Video Products Technical Bulletin 30-2003-095

DATE: **March 24, 2003**SUBJECT: **CAUTION WHEN REPLACING E BOARD**

MODEL: ***BVM-D24E1WA***
BVM-D24E1WE
BVM-D24E1WU
BVM-D32E1WA
BVM-D32E1WE
BVM-D32E1WU
BVM-F24
BVM-F24A
BVM-F24U

**Figure 1**

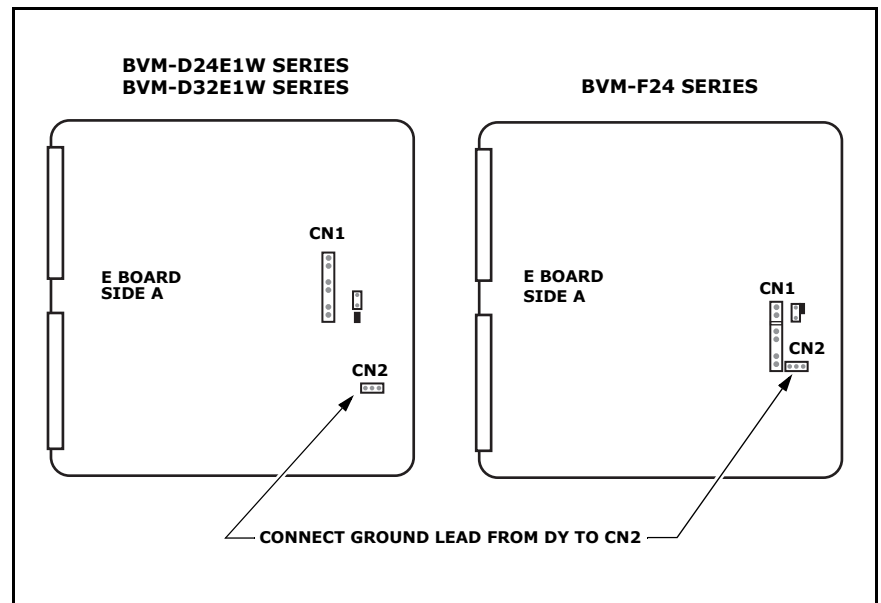
When replacing the E board and connecting the harness leading from the deflection yoke (DY), connect the lug terminal connector of the ground lead (black) to CN2. (See Figure 1.)

CAUTION: If the ground lead coming from the DY is inadvertently connected to TP8 (BVM-D24, BVM-D32) or TP3 (BVM-F24) of H.OUT, which is located next to CN1, resistors R26 and R27 on the DY may burn and smoke. Video appears normal even if the ground lead is connected incorrectly.
